# **ENERGY NORTHWEST**

April 28, 2003  
GO2-03-069

Subject: **COLUMBIA GENERATING STATION, DOCKET NO. 50-397  
REQUEST FOR ADDITIONAL INFORMATION REGARDING A  
REQUEST FOR AMENDMENT TO TECHNICAL SPECIFICATION  
2.1.1.2, MCPR SAFETY LIMIT AND SR 3.3.1.3.2, OSCILLATION  
POWER RANGE MONITOR-LPRM CALIBRATION FREQUENCY**

**REQUEST FOR ADDITIONAL INFORMATION REGARDING REQUEST FOR  
AMENDMENT TO TECHNICAL SPECIFICATION 2.1.1.2 AND SR 3.3.1.3.2**

Figure 1

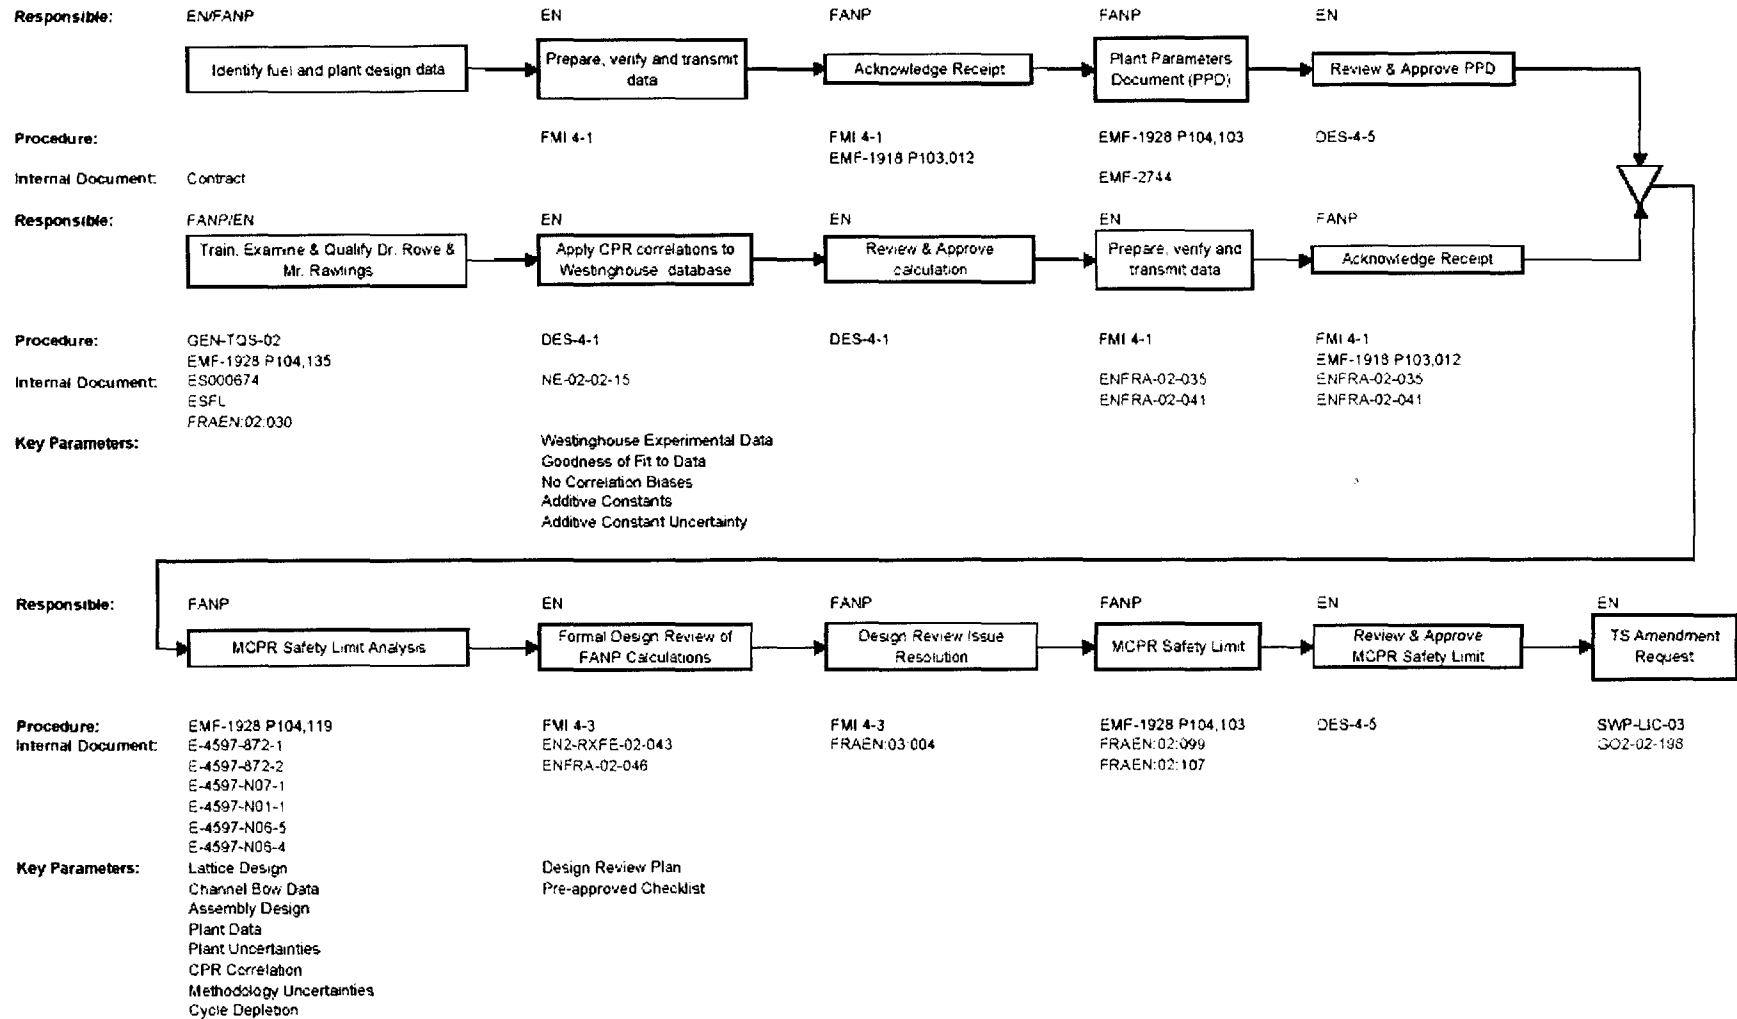
**“Cycle 17 will be the first cycle of operation with a mixed core of ABB/CE/Westinghouse SVEA-96 fuel and Framatome ANP ATRIUM-10 reload fuel. Provide a flow chart for the calculation interface and identify those key parameters in the calculation. Also, describe any applicable safeguard procedures used to verify that the mixed core analysis for the SLMCPR are accurate without any possible input errors for the calculation, and identify any routine check-out processes to verify that the result of the calculation for SLMCPR is conservative.”**

*The safety limit calculation is the intended calculation to address in this question.*

*With regards to the last sentence, provide a description of the processes used to ensure the information that is transmitted between the interfaces is accurate, correctly applied and the results are consistent and reasonable. Reference any procedures that implement the processes described.*

A flow chart, Figure 1, shows the Energy Northwest and Framatome ANP processes and interfaces that were utilized in determining the SLMCPR for Cycle 17. Table 1 provides a summary of the procedures and documents identified on the flow chart. Each summary describes the activity involved in the respective step of the overall design control process. Those steps that involve review of data for accuracy and completeness are shown on the figure and described in the table. The design control process complies with the requirements of 10 CFR 50 Appendix B.

The boxes in the flow chart identify the major activities associated with the overall design control process. The organization(s) responsible for each major activity is shown above each box. Implementing procedure(s) and the internal document(s) or output result, for each major activity are listed below each box.

Key parameters associated with the activity were obtained for the areas identified on the flow chart. More specific information regarding the parameters used in the SPCB CPR correlation is provided in ENFRA-02-035 and ENFRA-02-041 (Enclosure 4, References A.4 and A.5 and Table A.1 of Reference 1).

Based on following the process described above, we are confident that the data transmitted between Energy Northwest and Framatome ANP are accurate and the results are consistent and reasonable.
